Product Change Notice

(PCN Tracking Number: EE-QR-200701-01)

Customer:	ALL Customers
Renesas Product Type:	Synergy and RA HWQFN package products. The list of all affected products along with the new part numbers on page 9.
Description of Change:	New assembly and test factories. Further details stated on page 2
Reason for Change:	Renesas continuously changes manufacturing factories and assembly materials for stable supply.
Identification:	From the packing label or trace code, the production history data can be inquired.
Schedules:	Sample shipment & QT data: from b/o Nov. 2020 sequentially (p.9) Requested approval: Nov. 2020 or 3 months after sample delivery Change Implementation: from Jan. 2021 onwards sequentially
Anticipated Impact:	Fit, Form & Function: None Quality & Reliability: None QC Flow: None
Doc. No.:	EEQC-PCN-CR-20-0053
Internal Reference:	IMO-AZ-20-003-1

Düsseldorf, 15.07.2020

PACKING SPECIFICATION (TRAY)

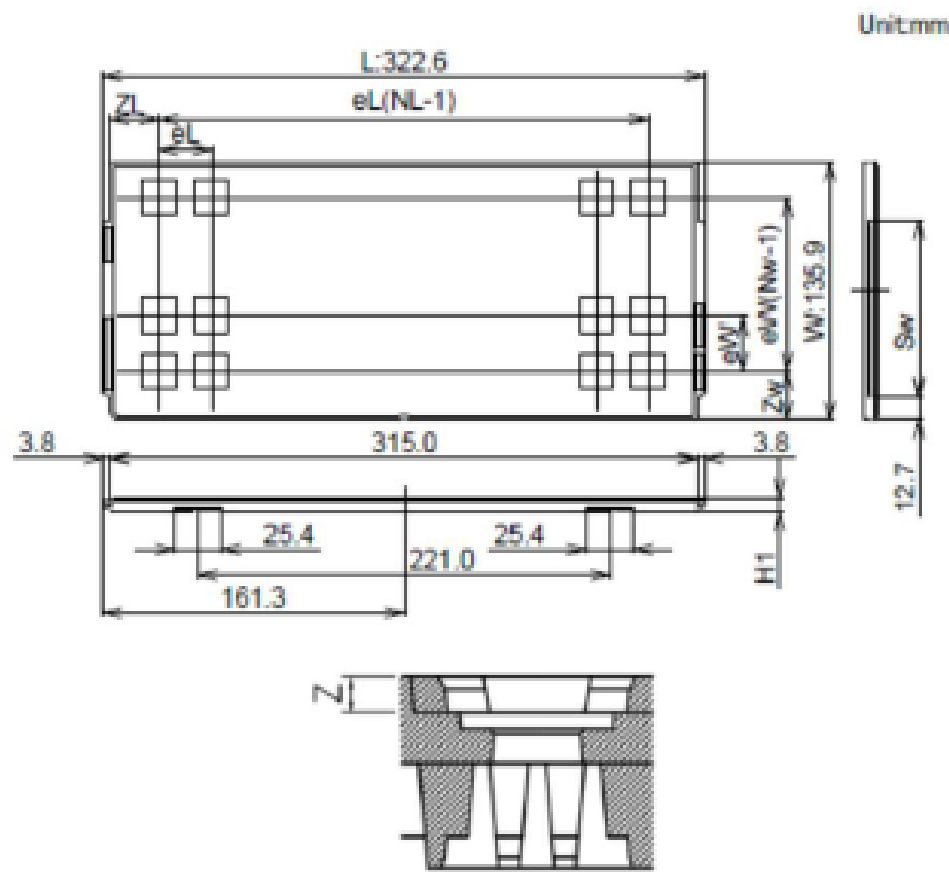
Tray Code		New	Current
		REV.C EAG0707-10	EAM0707-10
Position dimension of cells	Z	1.40	1.55
	Zw	11.55	10.35
	ZL	11.80	10.00
	eW	9.40	12.80
	eL	9.40	11.80
	Sw	92.1	92.1
Thickness (mm)	H1	7.62	7.62
Number of cells	Nw	13	10
	NL	32	26
Maximum storage pcs IC/Tray		416	260
Maximum storage pcs IC/Inner box		3328	2080
Material		Carbon PPE	Carbon PPE
Heat resistant temperature		135°C MAX	135°C MAX
JEDECorCustom		JEDEC	JEDEC
Surface resistance		Less than $1x10^{11}$Ω/□	Less than 1x1011Ω/□

PACKING SPECIFICATION (TRAY)

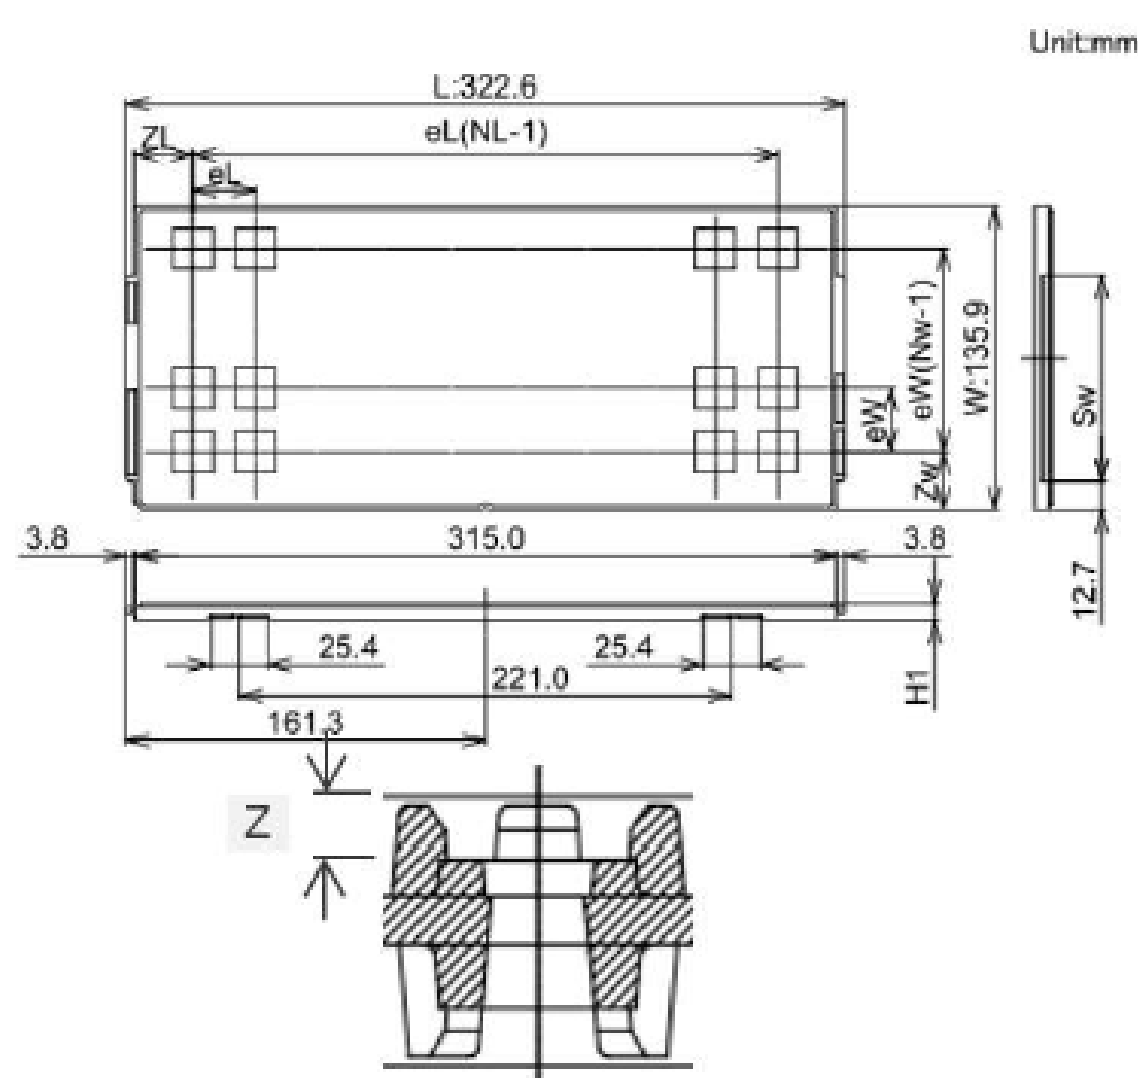
Tray Code		New	Current
		EAM050501-10	Rev.B EAM050503-10
Position dimension of cells	Z	1.75	1.50
	Zw	8.15	8.15
	ZL	7.90	7.90
	eW	9.20	9.20
	eL	8.80	8.80
	Sw	92.10	92.10
Thickness (mm)	H1	7.62	7.62
Number of cells	Nw	14	14
	NL	35	35
Maximum storage pcs IC/Tray		490	490
Maximum storage pcs IC/Inner box		3920	3920
Material		Carbon PPE	Carbon PPE
Heat resistant temperature		135ºC MAX	135ºC MAX
JEDECorCustom		JEDEC	JEDEC
Surface resistance		Less than 1x10^{11}Ω/□	Less than 1x10^{11}Ω/□
